City of Fairfax, Virginia
City Council Work Session

SUBJECT: Request of Regency Centers for a City Council work session to discuss a potential application for the redevelopment of Fairfax Shopping Center.

ISSUE(S): Informational Work Session of City Council to discuss a proposed plan for the redevelopment of Fairfax Shopping Center. Although a formal application has not yet been submitted, the applicant has prepared a concept plan for discussion. Initial feedback is sought from City Council regarding the submitted concept plan.

Figure 5: Conceptual Site Plan

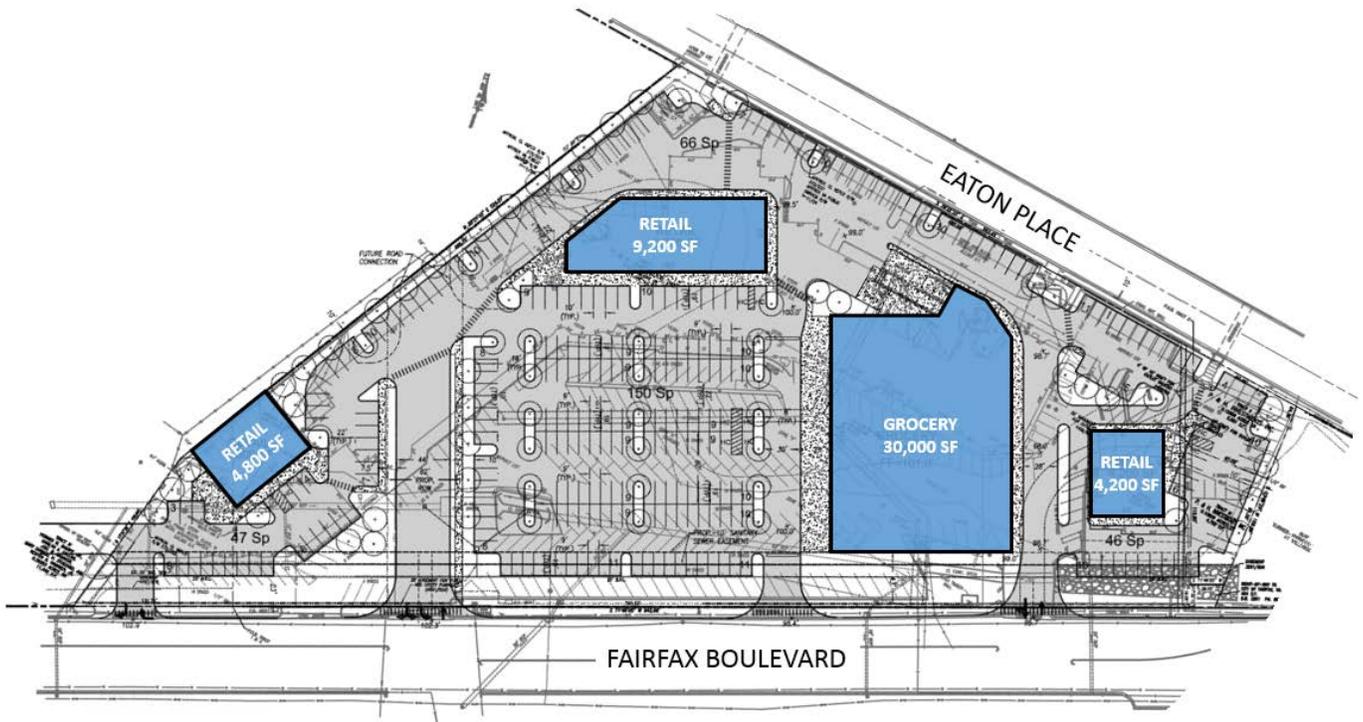
Land Use: Although the proposal does not contain multiple uses, as would be preferred in a mixed use district, the Comprehensive Plan acknowledges that the types of uses that are generally considered acceptable should be flexible to accommodate market conditions provided that they contribute toward the cohesive vision of the plan. Retail is a supported use in mixed use districts and an entirely retail development may be appropriate; however, it should be designed to accommodate the physical characteristics described in Attachment 1 that contribute toward the comprehensive vision for the Northfax Center, including buildings that are oriented toward streets, walkable block sizes, and inclusion of open spaces and public gathering areas. In addition, the site should be arranged to allow potential future development within the Northfax Center to function along with this site in a cohesive manner. The proposed site layout is more consistent with that of a typical shopping center.

The Comprehensive Plan vision supports an active street presence for all three of the largest street frontages for this site at Eaton Place, Fairfax Boulevard and University Drive which would be a challenge to achieve. The proposed plan, however, generally directs active engagement inward and toward surface parking areas, although the grocery store could include an outdoor seating oriented toward Fairfax Boulevard.

- The proposal contributes toward the creation of an “interconnected series of small blocks” by accommodating the potential University Drive Extension though it does not consolidate access points along Fairfax Boulevard.

- Due to the utility easements along Fairfax Boulevard, which generally do not allow for tree plantings, the ability for any kind of redevelopment on the subject site to contribute toward “a tree-lined boulevard” is limited. The proposed plan includes smaller plantings within the easement but does not allow for larger plantings outside of the easements which could soften the appearance of the building and parking areas of the site toward Fairfax Boulevard. The plan does not provide adequate space for appropriate plantings of street trees along Eaton Place.

- The plan does not include a provision for slow-lanes, though it does allow for inter-parcel connectivity to the west. This slow-lane component of the Fairfax Boulevard Master Plan could support bringing retail uses closer to the Boulevard while allowing for convenient, accessible parking.

- The resulting block length between University Drive and Eaton Place along Fairfax Boulevard is over 800 feet. A mid-block pedestrian accessway through this site, from Fairfax Boulevard to Eaton Place, would improve pedestrian accessibility in this portion of the Northfax Center. The new zoning ordinance prescribes mid-block pedestrian accessways across blocks that are over 600 feet in length. The proposed plan preserves access to existing mid-block crosswalks across Eaton Place and provides additional linkages to internal sidewalks.
